UNITED STATES PATENT AND TRADEMARK OFFICE

APPLICATION NO.	FILING DATE	FIRST NAMED INVENTOR	ATTORNEY DOCKET NO.	CONFIRMATION NO.
10/813,589	03/30/2004	Susanne A. Paul	SIL.P0078	4323

Office Action Summary	Application No. 10/813,589	Applicant(s) PAUL ET AL.	
	Examiner Michael B. Shingleton	Art Unit 2815

DETAILED ACTION***Claim Rejections - 35 USC § 103***

FIG. 3

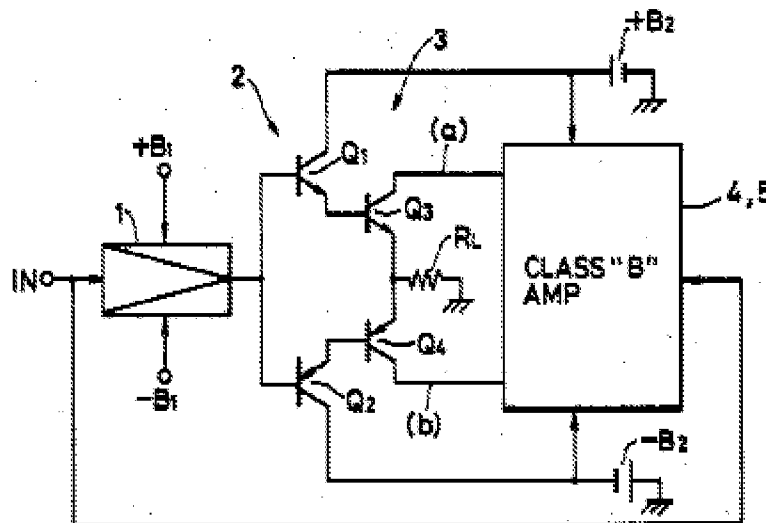
Figure 3 and the relevant text of Koinuma disclose a power amplifier arrangement and method of providing an amplifier with a preamplifier 1 (input stage) and an output stage (2 and 3) that is supplied with two different power sources (B_1 and B_2). The voltage B_2 is of a greater magnitude than that of B_1 . (See column 3, around line 36)

Column 5, around line 63.

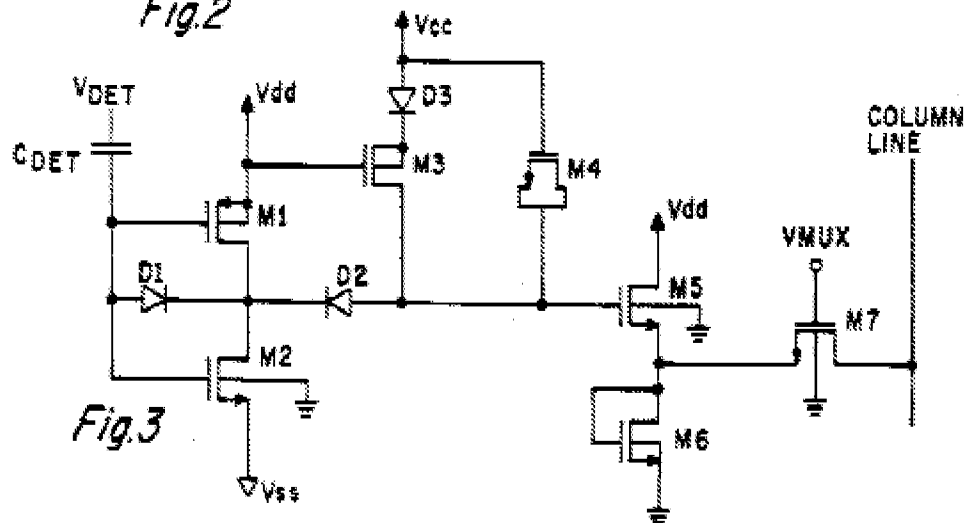
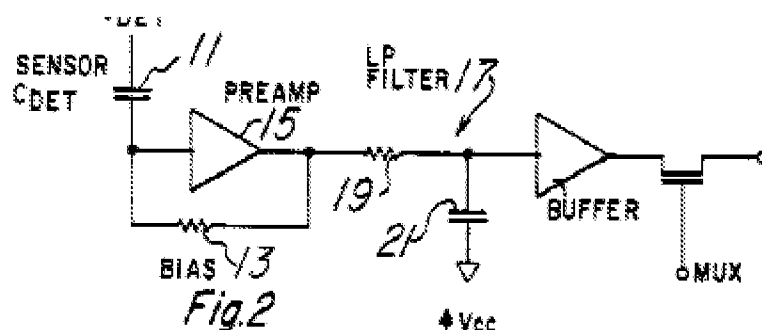
In addition to that above Koinuma is silent on the use of a CMOS based preamplifier and CMOS based output stage. Koinuma utilizes bi-polar transistors for the transistor elements in the output stage. It is commonly known but Engbretson shows that a FET is an equivalent structure to a bi-polar design. See column 5, around line 63.

Therefore, because these two transistor structures were known as art-recognized equivalents at the time the invention was made, one of ordinary skill in the art would have found it obvious to substitute the FET structure for the bipolar elements in Koinuma.
